Errata Sheet

Rel. 1.4, 2016-11

Device	**XMC1200**
Marking/Step	**EES-AB, ES-AB, AB**
Package	**PG-TSSOP-16/28/38, PG-VQFN-24/40**

Figure 1 Clock Selection Diagram for CCU4/CCU8

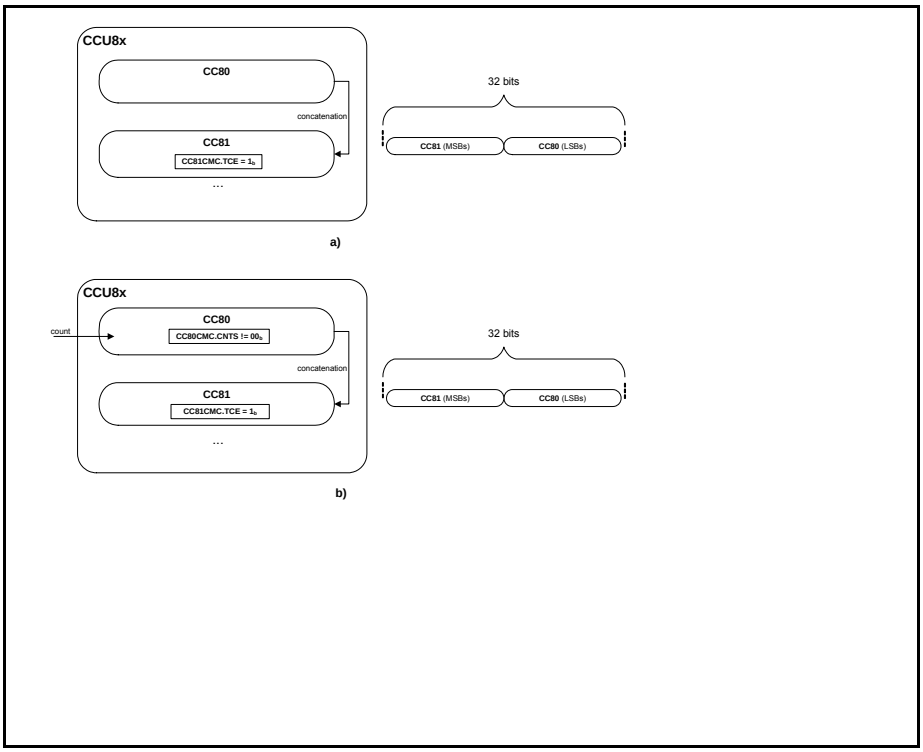
CCU_AI.005 CCU4 and CCU8 External IP clock Usage

Each CCU4/CCU8 module offers the possibility of selecting an external signal to be used as the master clock for every timer inside the module Figure 1. External signal in this context is understood as a signal connected to other module/IP or connected to the device ports.

Currently is only possible to use an external signal as Timer Clock when a division ratio of 2 or higher is selected. When no division is selected (divided by 1), the external signal cannot be used.

The user must program the PSIV field of each Timer Slice with a value different from 0000_B - minimum division value is /2.

This is only applicable if the Module Clock provided by the system (the normal default configuration and use case scenario) is not being used. In the case that the normal clock configured and programmed at system level is being used, there is not any type of constraints.

Workaround

None.
